# City of Eustis

TO: Eustis City Commission  
FROM: Tom Carrino, City Manager  
DATE: May 16, 2024  
RE: Resolution Number 24-41: Approving a Site Plan with Waivers for a Self-Storage Facility at David Walker Drive and Huffstetler Drive (Alternate Key Number 3853069).

Resolution Number 24-41 approving a site plan with waivers for a self-storage facility on approximately 1.07 +/- acres located at David Walker Drive and Huffstetler Drive (alternate key number 3853069).

Elevations:  
Building 1

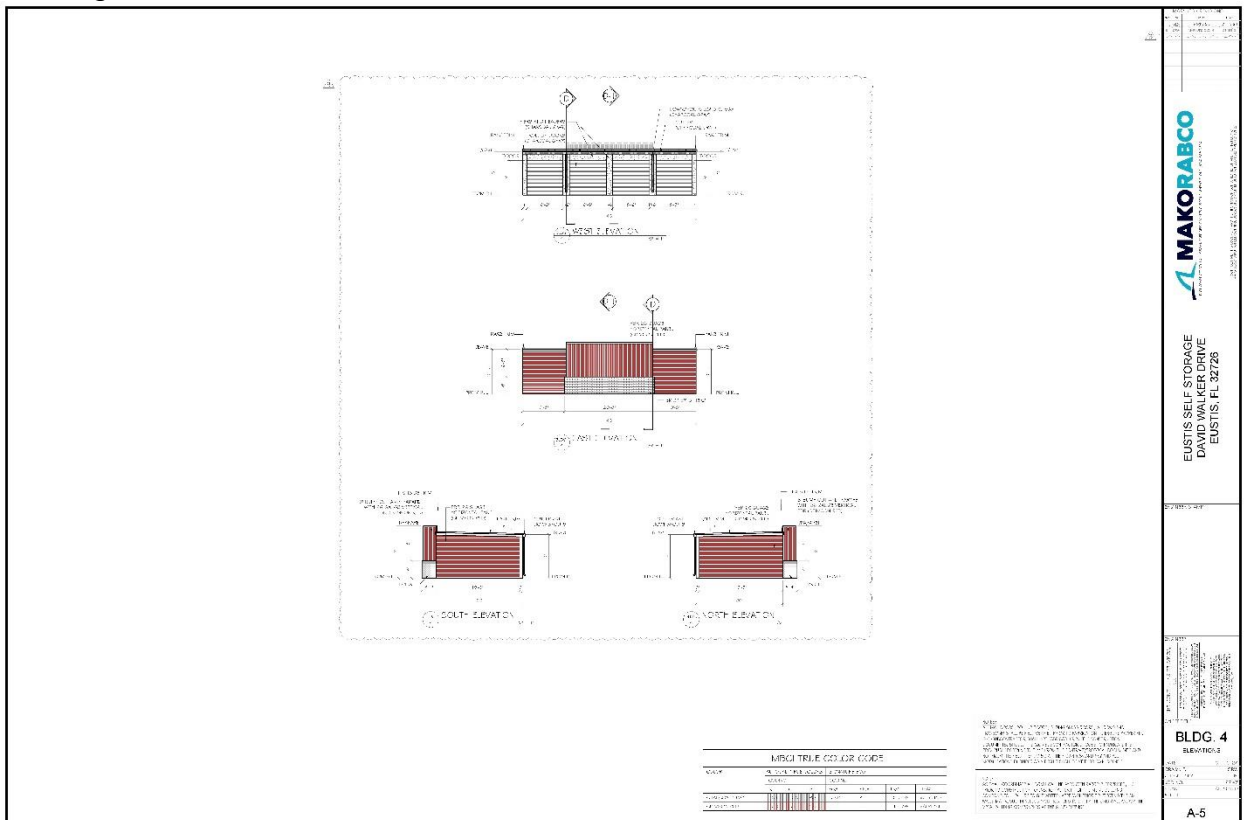
For Section 115-6.1(d) Building Design, the applicant has incorporated varying cornice treatments providing a varying façade line along the shopping plaza interior elevation and the Huffstetler Road and David Walker Road elevation. The plan also incorporates variegation of depths with recesses along the building facades for the shopping plaza interior elevation and the Huffstetler Road and David Walker Road elevation. The proposed buildings do not incorporate windows due to the nature of their use, and there is no defined/designated "public entrance", therefore the applicant does not fully comply with Section 115-6.1(d) as the section calls for the incorporation of three (3) or more elements; however, the nature of the building does not logically allow for incorporation of other elements.

Due to the nature of the use of the buildings and the location of the site, Staff does not find that the requested waivers detract from the intent of the Land Development Regulations for
